Access Compliance Report

Public Rights-of-Way

Intersection ID: 10016842	Main Street: N_TRYON_ST	Cross Street: N/A	Location: N
ADA ID: 955DEF1EFFED	Ramp Type: PerpDiag	Initial Pass/Fail: Fail	Overall Compliance: No
		Severity Score: 60

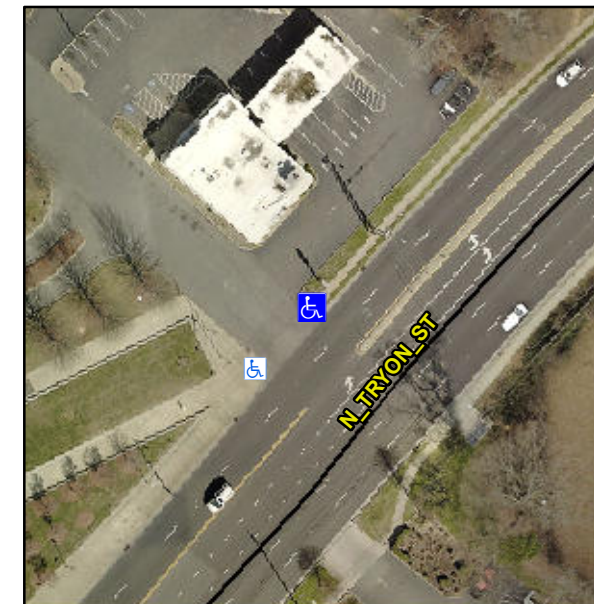
Not Found, R304.5.1, R304.2.2, R304.5.3

Compliance	Description	Data	Compliance	Description	Data
N/A	Ramp Length (in)	52.0	No	Ramp Slope (%)	11.1
No	Ramp Width (in)	24.0	No	Ramp XSlope (%)	6.3
N/A	Flare Type LT	N/A	N/A	Flare Type RT	N/A
N/A	Flare Slope LT (%)	N/A	N/A	Flare Slope RT (%)	N/A
N/A	Flare Traversable LT?	N/A	N/A	Flare Traversable RT?	N/A
N/A	Landing Length (in)	N/A	N/A	DWS Provided?	N/A
N/A	Landing Width (in)	N/A	N/A	DWS Contrast?	N/A
N/A	Landing Slope (%)	N/A	N/A	DWS Length (in)	N/A
N/A	Landing X Slope (%)	N/A	N/A	DWS Full Width?	N/A
N/A	Landing Curb? (Y/N)	N/A	N/A	DWS Offset (in)	N/A
N/A	Shared Landing?	N/A			
N/A	Gutter Ponding?	N/A	N/A	Gutter Slope (%)	N/A
N/A	Gutter Lip Ht (in)	N/A	N/A	Gutter X Slope (%)	N/A
N/A	Painted X Walk1?	No	N/A	Painted X Walk2?	No
	X Walk 1 Direction	To SW		X Walk 2 Direction	To SE
N/A	X Walk 1 Width (in)	N/A	N/A	X Walk 2 Width (in)	N/A
	X Walk 1 Slope (%)	2.3		X Walk 2 Slope (%)	0.7
	X Walk 1 X Slope (%)	5.2		X Walk 2 X Slope (%)	2.7

Remove & Replace Curb Ramp With Two New Directional Ramps or Equivalent.
